From: BRYAN Martin (EXTERNAL AREVA) [Martin.Bryan.ext@areva.com]
Sent: Wednesday, July 14, 2010 11:42 AM
To: Tesfaye, Getachew
Cc: DELANO Karen (AREVA); ROMINE Judy (AREVA); BENNETT Kathy (AREVA); RYAN Tom (AREVA)
Subject: Response to U.S. EPR Design Certification Application RAI No. 293, FSAR Ch. 16 OPEN ITEM, Supplement 2
Attachments: RAI 293 Supplement 2 Response US EPR DC.pdf

Subject: Response to U.S. EPR Design Certification Application RAI No. 293, FSAR Ch. 16 OPEN ITEM, Supplement 2
Sent Date: 7/14/2010 11:42:25 AM
Received Date: 7/14/2010 11:42:30 AM
From: BRYAN Martin (EXTERNAL AREVA)

QUESTIONS for Technical Specification Branch (CTSB)

Figure 16-304-1. Treatment of Accumulation for Main Steam Safety Valves

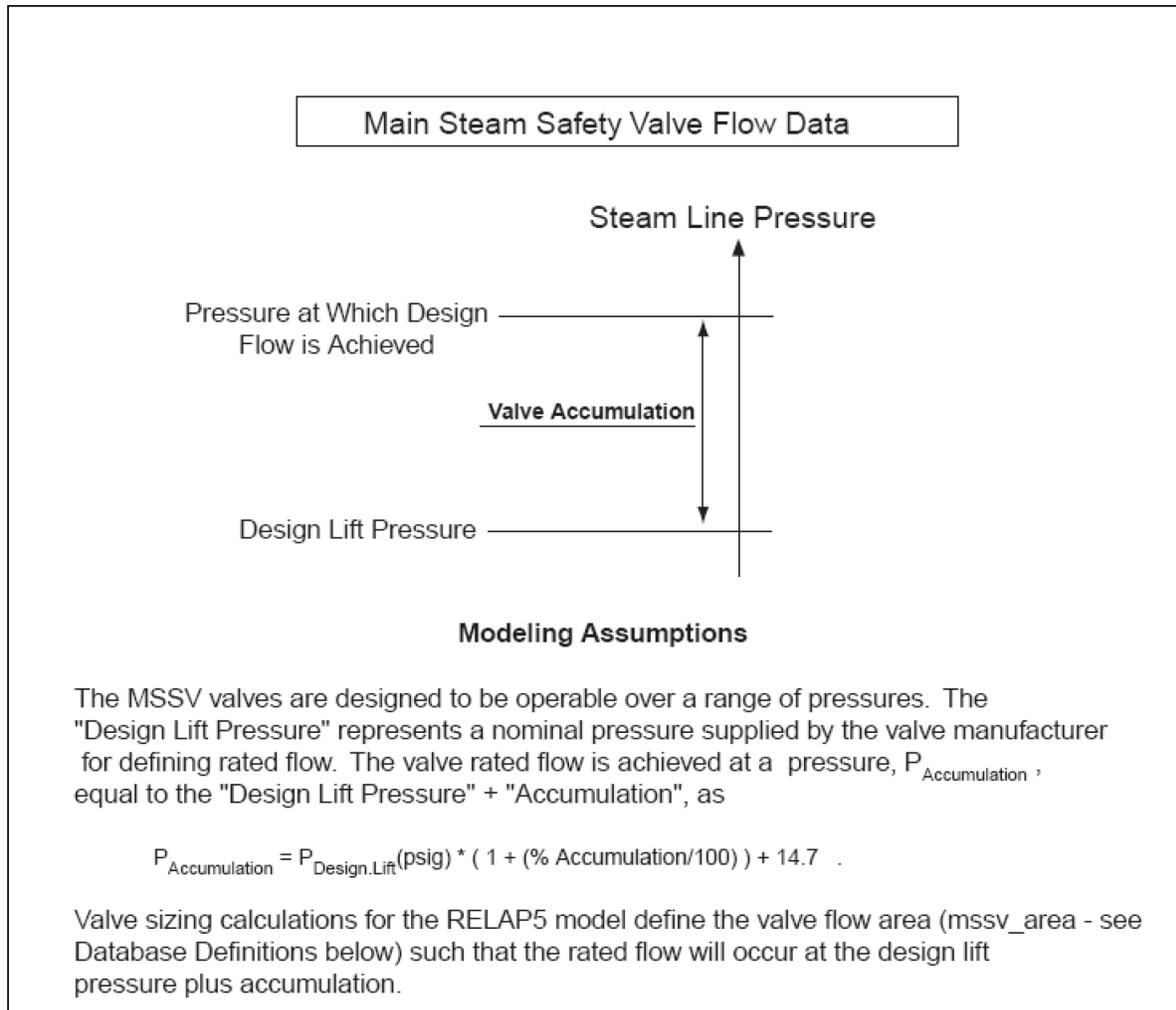
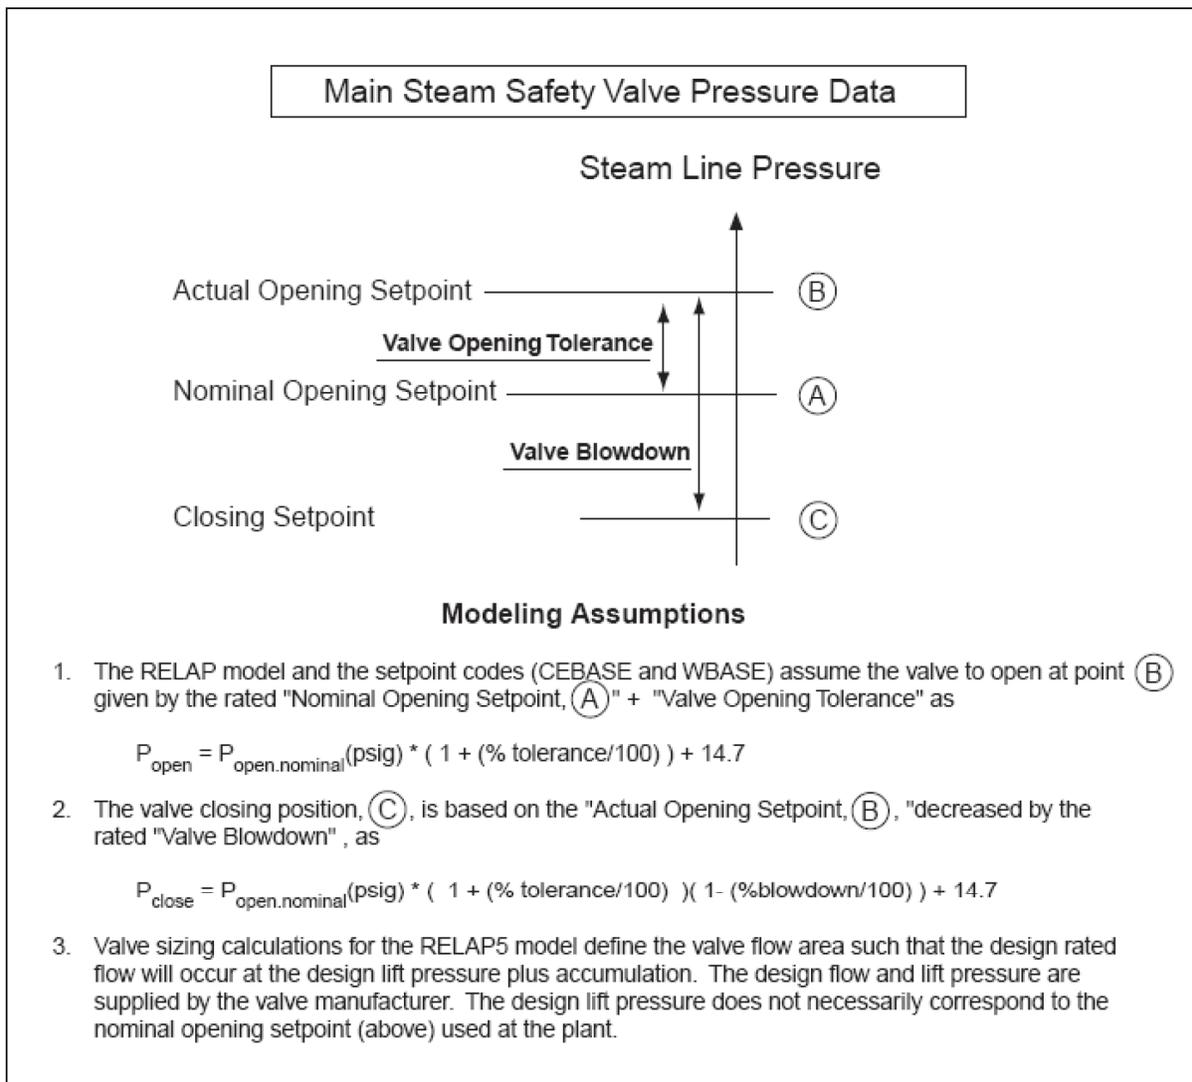
In its response letter dated December 12, 2008, the applicant stated "the flow area of the main steam safety valves is calculated based on rated flow rate being achieved when system pressure is equal to nominal setpoint pressure, plus 3% accumulation. The MSSV setpoint pressure used in the safety evaluation is calculated as the nominal setpoint pressure, plus 3% setpoint uncertainty (to account for drift). Since accumulation and uncertainty have the same value of 3%, rated flow will be achieved at the initial valve opening." The applicant also indicated that no change to the EPR FSAR is needed.

The staff finds the above response unacceptable in that combining an one-sided + 3% accumulation with a two-sided +/- 3% setpoint uncertainty can result in a total of + 6% difference from the nominal setpoint value. The rated lift capacity assumed in the accident analysis should be at the upper limit of the combined tolerance (e.g., at the RCS pressure of 1608.7 psia instead 1518.5 psia for the first MSSV).

The lower and upper main steam safety valves (MSSV) have set pressures of 1460 psig and 1490 psig, respectively. Both MSSVs are attached directly to the main steam line. The U.S. EPR MSSVs use an accumulation of 3% above the set pressure before rated relieving capacity is achieved. This is the accumulation (rated lift) value specified by ASME Code, Section III, Division 1, NC-7512.1(a). A tolerance of $\pm 3\%$ is utilized in the overpressure analyses to account for potential set pressure drift during plant operation rather than utilizing the less limiting

ASME specified $\pm 1\%$ tolerance. A $\pm 1\%$ tolerance is utilized as the “as left” set pressure condition after testing and inspection. Per AREVA response to RAI 293, Question 16-303, justification for the use of a $\pm 3\%$ tolerance will be included in the U.S. EPR Overpressure Protection Report as required by ASME Code, Section III, Division 1, NC-7512.2(a).

At the operating nuclear plant, MSSV set pressure tolerance is established by inservice testing of the set pressure which accounts for drift or any other uncertainty.

For overpressure events, the valve is not credited to open until the inlet pressure equals the set pressure plus drift. If the valve drift is equal to the accumulation (as is the case for the U.S. EPR MSSVs), the valve is capable of relieving rated flow once the inlet pressure equals the set pressure plus drift. Since for this case the valve is opening at the same inlet pressure as the set pressure plus accumulation, only the physical time required for the valve to fully open needs to be accounted for. Safety valves typically require 20 to 30 milliseconds to fully open. A 40 millisecond delay is assumed for the opening of the U.S. EPR MSSVs.

Figures 16-304-1 and 16-304-2 provide a graphical explanation as to the application of accumulation and tolerance for the main steam safety valves. It should be noted that for the accumulation description, the design lift pressure is equal to the set pressure of the U.S. EPR MSSVs (i.e., 1460 and 1490 psig).
